Deemed Provisions – Cl 67 Matters to be considered by local Government

Land Use:

Extract of the Local Structure Plan

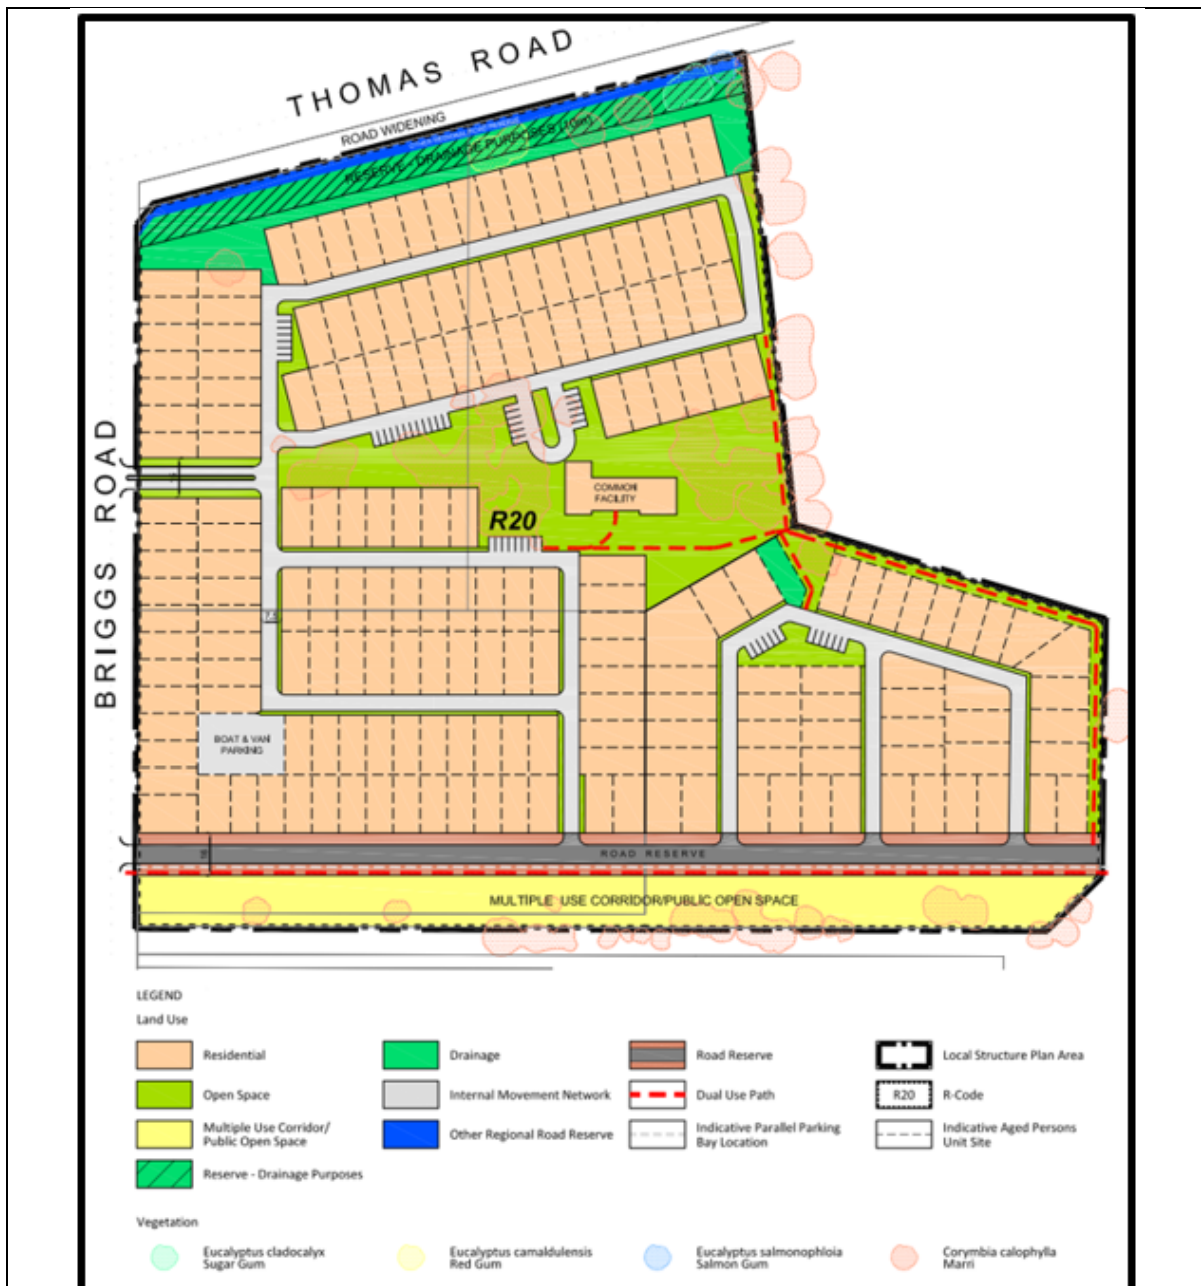
While generally consistent, the proposal seeks approval for a modified development layout from the approved LSP. These modifications to the LSP include:

- A reduction in the drainage area to the north of the site, adjacent to Thomas Road from 4,733m² down to 2,328m²;
- Reduced width of the road reserve to the south of the site;
- An increase in the number of dwellings from 196 to 202; and
- An average lot size of 336m², whereas the average lot size for the R25 density is 350m².

Despite these variations, the LSP is a document that provides guidance to development, and is required to be given regard to in undertaking assessment of the application. The LSP also aims to provide high-quality development for aging members of the community. Officers consider the

development meets this intent of the LSP.

Proposed stormwater management system pictured

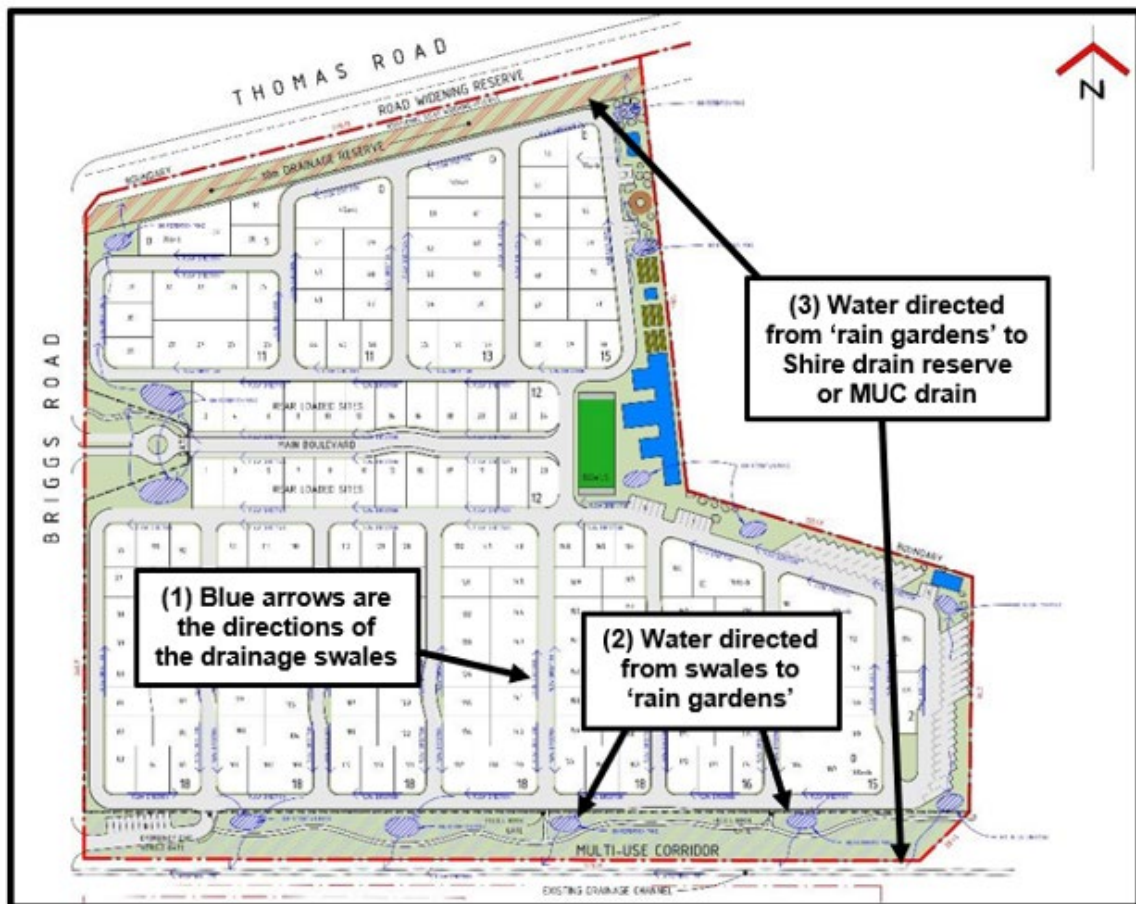
The applicant has not at this stage undertaken detailed engineering designs for the development. In order to ensure compliance with the Byford District Water Management Strategy and LWMS prepared as part of the original LSP, a condition is recommended to require an updated LWMS (which reflects also the advice of DWER) and subsequent to this, a detailed Urban Water Management Plan (UWMP). These processes will address the following matters:

- The capacity of the drainage infrastructure, including contingency for significant storm events;
- How the swales will direct water through obstacles such as road reserves, driveways and the acoustic wall on the north lot boundary;
- The location of the southern row of dwellings being positioned in the floodway of the drain to the south of site;
- The management measures to be employed to ensure water quality is maintained;
- How much fill is necessary to be imported into site; and
- What measures will be in place to ensure the survivability or replacement of vegetation within the swales and 'rain gardens'.

Location of community facilities in the Flame Zone

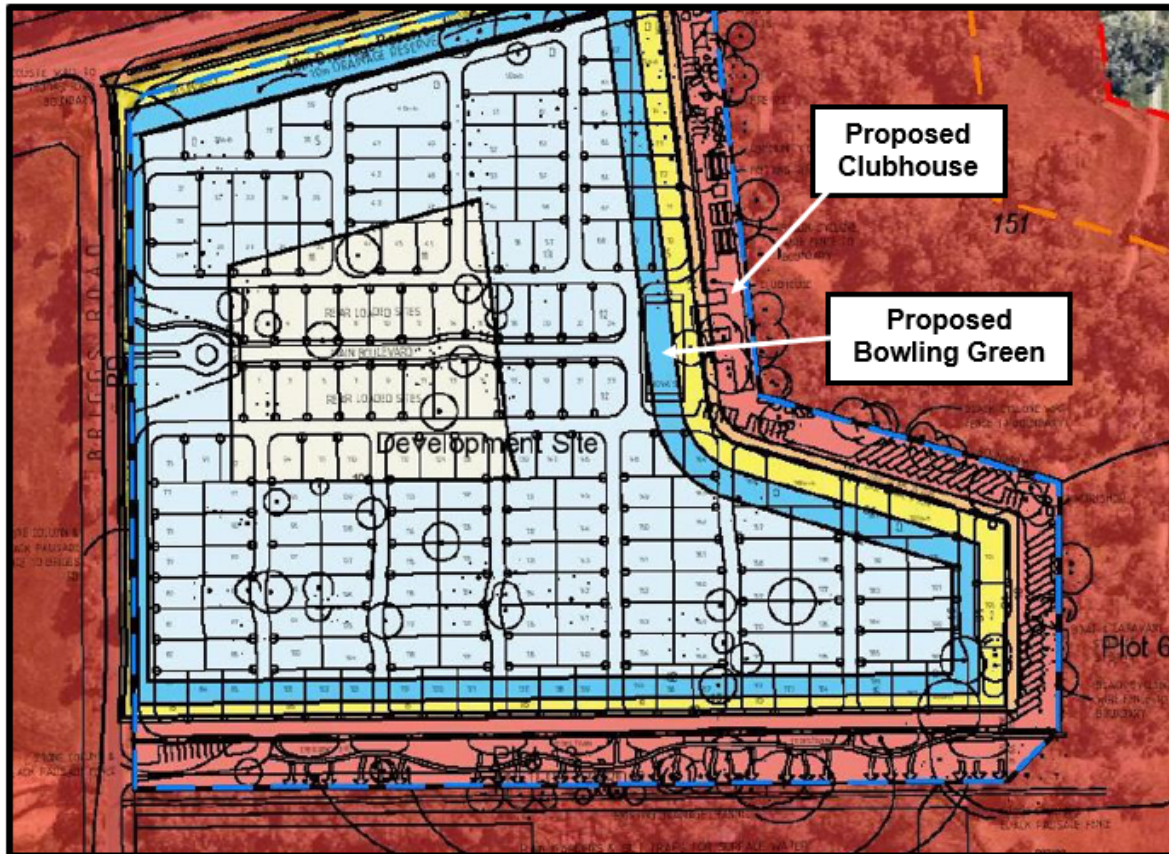
The BMP demonstrates that a worst-case scenario bushfire attack level (BAL) rating for the dwellings would be BAL-29, consistent with the requirements of SPP3.7. The BAL contour map however identifies that the Clubhouse is within Flame Zone, as depicted below.

As the building is considered habitable (where people live, work, study or are entertained), Officers raised this as a concern with the applicant and recommended that the building be relocated to where the bowling green is situated and vice versa. SPP3.7 states that development applications that result in a rating of BAL-40 or Flame Zone will not be supported unless it is considered 'minor development' or 'unavoidable development', which the proposal is not considered.

Officers consider that the justification provided by the applicant goes further to mitigate the risks associated with bushfire and that it could be appropriately managed. The building would be used by residents of the development who would be aware of their surroundings and the evacuation measures in place should a bushfire occur.

Emergency egress route (red arrows) during bushfire event

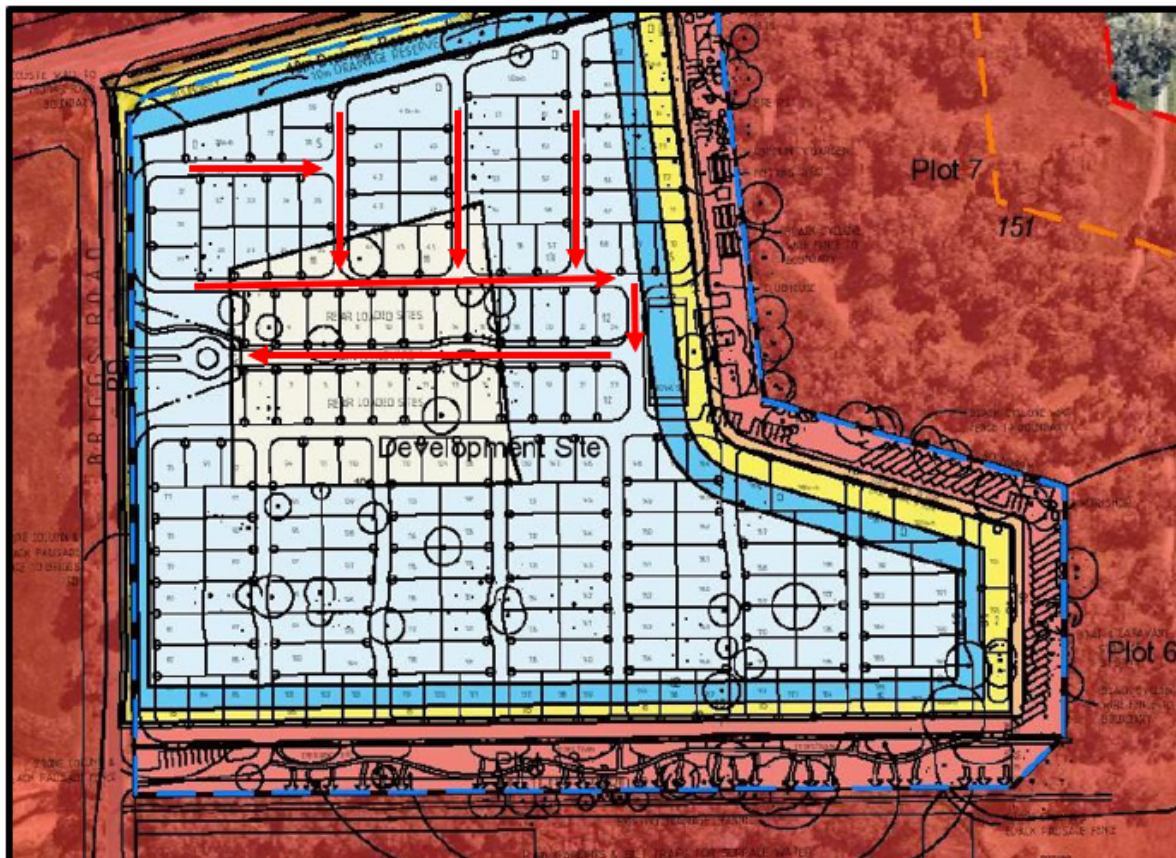
The Guidelines require that vehicular access allows for the provision of public road access in two different directions to at least two suitable destinations. The subject application satisfies this requirement. However, should a bushfire occur within the Flame Zone area to the east, residents located towards the north of the site would be required to travel towards the bushfire before exiting the site onto Briggs Road as depicted below:

Officers recommend to further substantiate the risk, a further emergency access is created for the residents to the north.

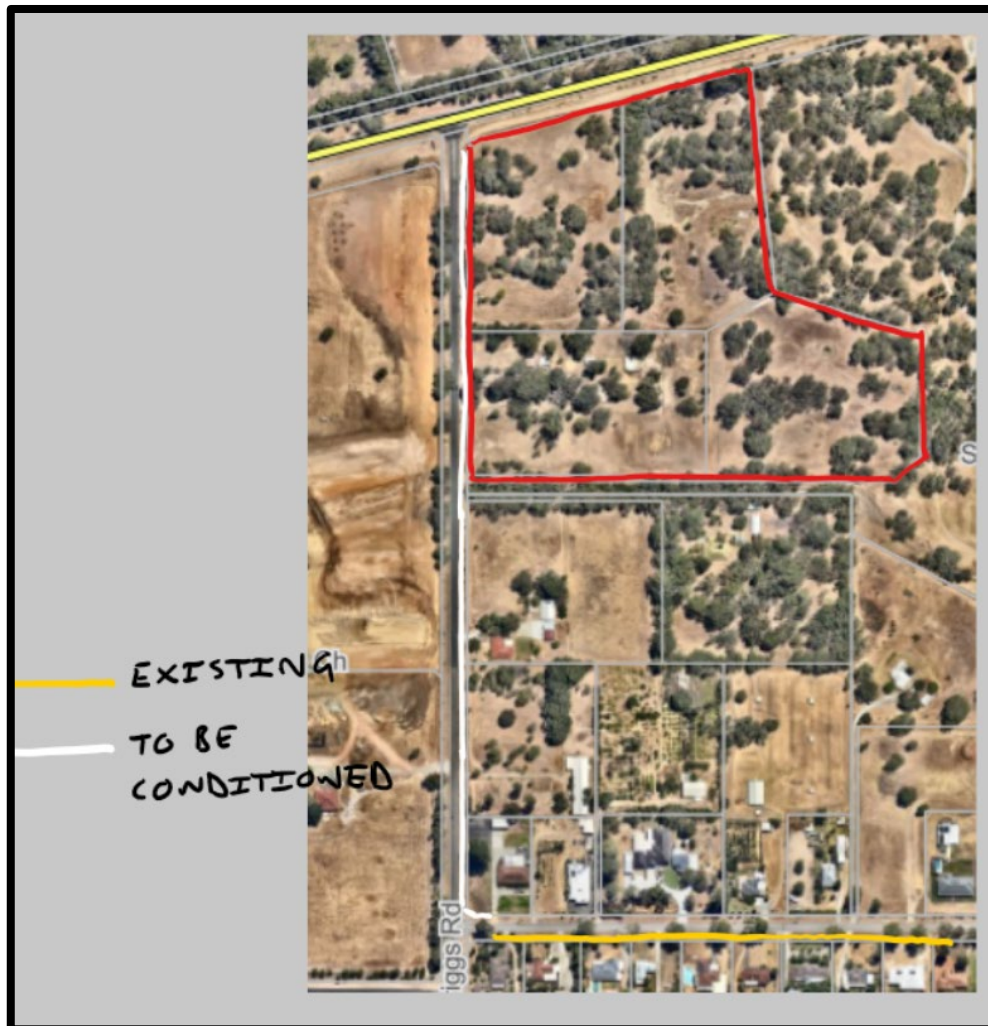
Officers generally concur with this finding given the road upgrades taking place as part of the subdivision works for Byford Meadows Stage 8. However, there is a safety issue associated with the lack of an urban standard verge on the eastern verge area adjoining the subject land, and connecting the subject land southwards to the local footpath network on Larsen Rd.

As shown in the following image, the site will be isolated from a safe pedestrian path, and officers consider that this needs to be addressed as part of approval of the development. By including a footpath on the eastern verge that connects south to the existing network along Larsen Rd, elderly residents (specifically) will not be forced to cross Briggs Rd and access the path network being built by the adjoining subdivision. This will enable safer access to amenities like the Byford Town Centre.

The main boulevard section is shown on the top image and the typical street elevation at the bottom

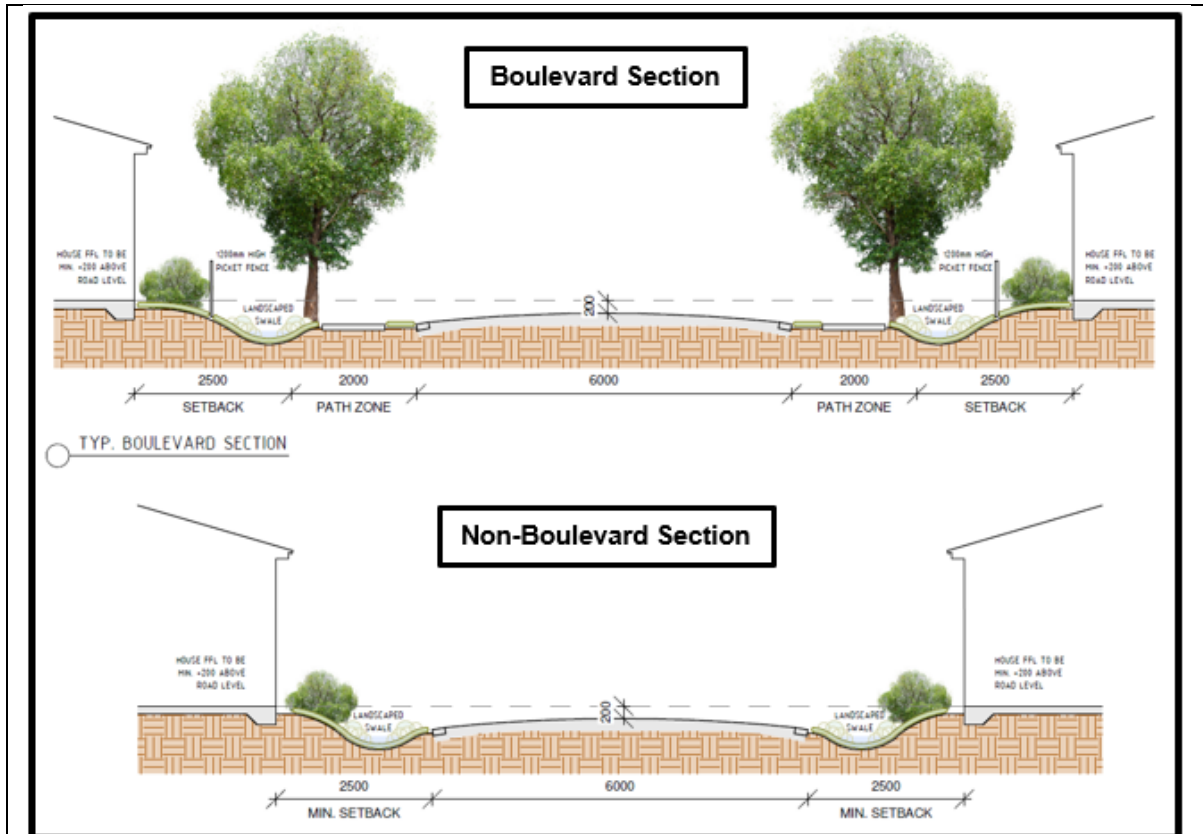
In terms of carriageway widths associated with grouped dwelling developments the State Planning Policy 7.3 - Residential Design Codes (Volume 1) (R-Codes) requires a 12m minimum total width, inclusive of a minimum 5.5m wide road and 1.2m wide footpath. The current layout of the communal streets provides a 6m wide road only. No footpaths are provided apart from on the main boulevard that leads to the communal facility to the east of site. This is detailed below.

The applicant proposes that internal roads, as private roads only, will be enforced through their design and development rules, to not exceed a speed limit of 8km/hr. This design and enforced speed regulation in the private estate, will enable safe sharing of space by both vehicles and pedestrians.
